SERVICE BULLETIN SB00.15

Machines/Models:LX31/41/50 4WD **Serial Numbers:** 2747 -3797

PURPOSE: Enhance Brake Durability

PROCEDURE REQUIRED: Install Orifice and Spring, adjust the Counterbalance and Bi-Directional Relief Valves

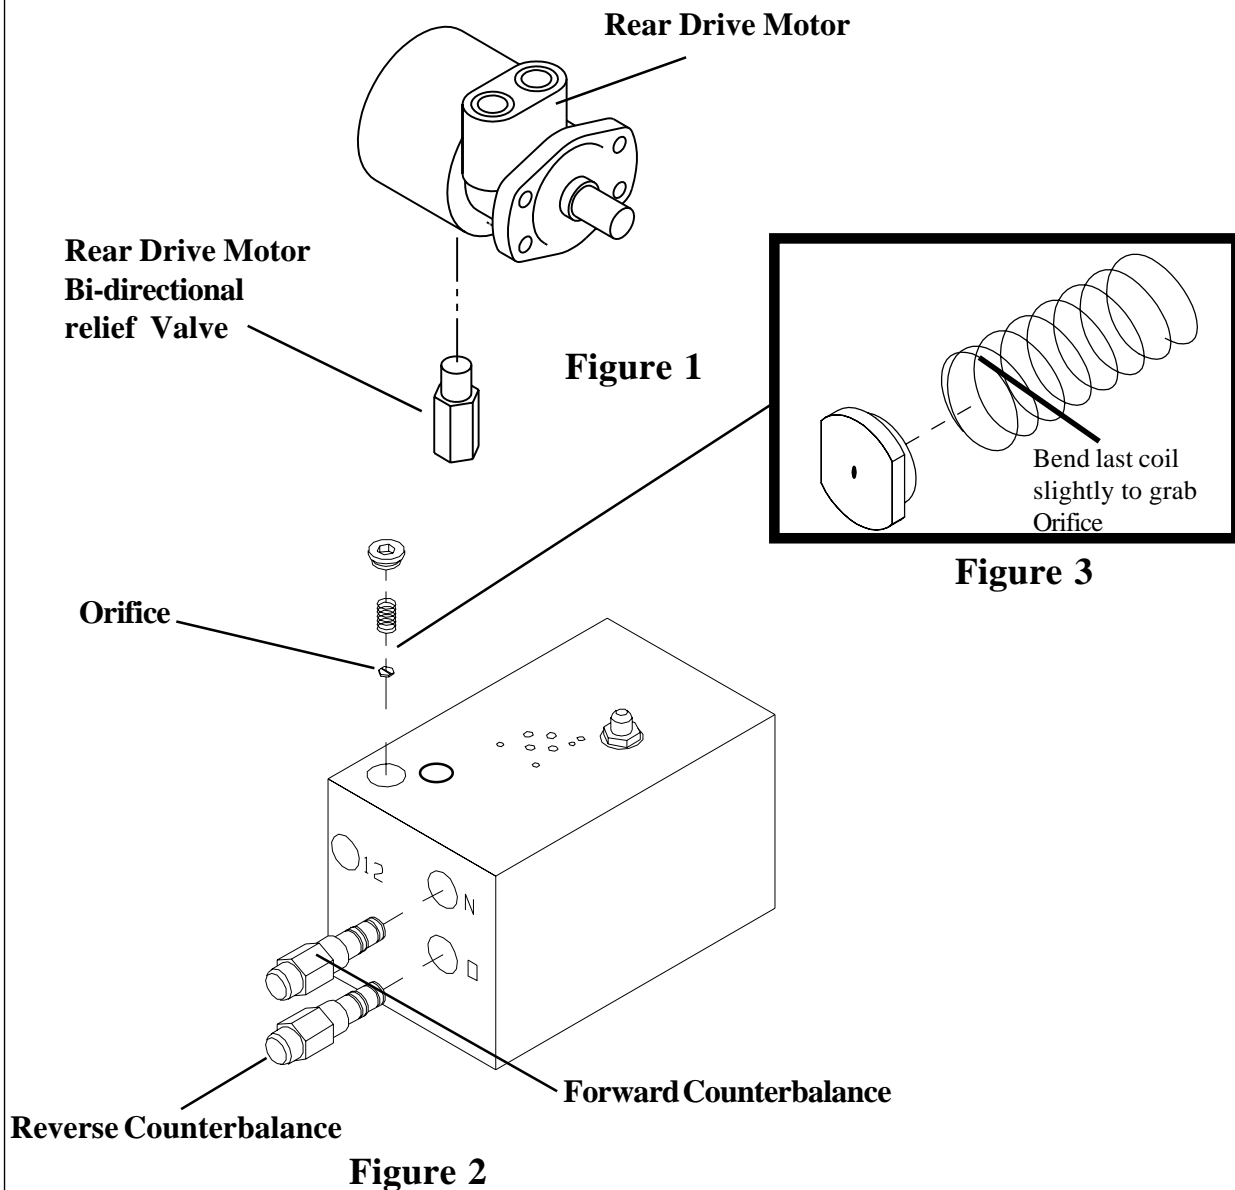
1. Locate the Left (Right) Bi-Directional Relief Valve (see Figure 1).
2. Loosen the Bi-Directional Relief Valve locknut (remove tamper proof cap if applicable).
3. Turn the valve clockwise until it gently rests against the seat.
4. Turn the valve counterclockwise 4 1/4 turns.
5. Torque the locknut to 3 Ft. Lbs (4 Nm).
6. Repeat steps 1 through 5 for the Right Rear Bidirectional Relief.

1. Locate the Forward (Reverse) Counter Balance Valve (see Figure 2).
2. Loosen the locknut.
3. Turn the valve clockwise until it gently rests against the seat.
4. Turn the valve counter clockwise 4 turns.
5. Torque the locknut to 3 Ft. Lbs (4 Nm).
6. Repeat steps 1 through 5 for the Reverse Counter Balance Valves as follows.

1. Locate port in the top of Main Hydraulic Manifold and remove the plug (a blunt tap with a small hammer on the top of the plug will ease removal)(see Figure 2).
